HISTORIC AND DESIGN REVIEW COMMISSION

May 15, 2024

HDRC CASE NO: 2024-167
ADDRESS: 1943 W SUMMIT AVE
LEGAL DESCRIPTION: NCB 1941 BLK 29 LOT 11
ZONING: R-6, H
CITY COUNCIL DIST.: 7
DISTRICT: Monticello Park Historic District
APPLICANT: ROBERT SAUCEDO
OWNER: MENG TESSI/MENG TESSIE & HSIN NIEN
TYPE OF WORK: Demolition of the rear accessory structure and new construction of a rear accessory structure
APPLICATION RECEIVED: April 03, 2024
60-DAY REVIEW: June 02, 2024
CASE MANAGER: Rachel Rettaliata

1. Demolish the existing rear accessory structure.
2. Construct a new approximately 405-square-foot, 1-story rear accessory structure.

ALL SIDE VIEWS OF GARAGE

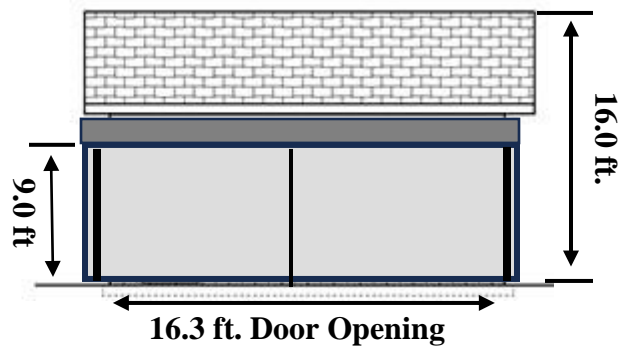
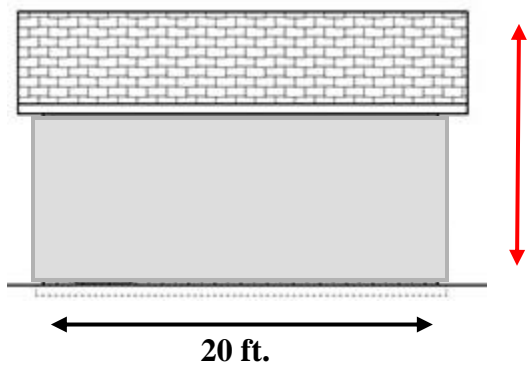
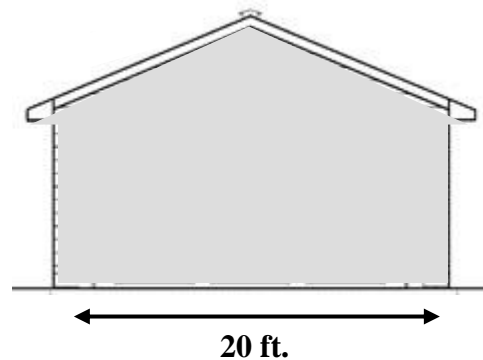
- j. **NEW CONSTRUCTION: RELATIONSHIP OF SOLIDS TO VOIDS** – Per Guideline 2.C.i. for New Construction, window and door openings with similar proportions of wall to window space as typical with nearby historic facades should be incorporated into new construction. The applicant has proposed to install two garage bays on the front façade (south elevation) of the structure and one (1) pedestrian door on the west elevation. The applicant has not proposed to install any window openings on the structure. The existing structure is a two-bay auto structure that does not feature windows but does feature a divided bay configuration. Staff finds that proposed fenestration pattern is generally appropriate, but a divided-bay garage is more appropriate for the south elevation. Staff finds that the pedestrian door should be made of wood or be wood-look, garage doors should be wood or wood-look, and the south side of the garage should feature a divided bay configuration.

- i. That the south elevation of the garage features a divided bay configuration based on finding j. The applicant must submit updated elevation drawings to staff for review and approval prior to the issuance of a Certificate of Appropriateness.
- ii. That the applicant submits final material specifications for wood or wood-look pedestrian and garage doors and for composite siding that features a reveal of no more than 6 inches and a smooth finish to staff for review and approval prior to the issuance of a Certificate of Appropriateness based on finding k.
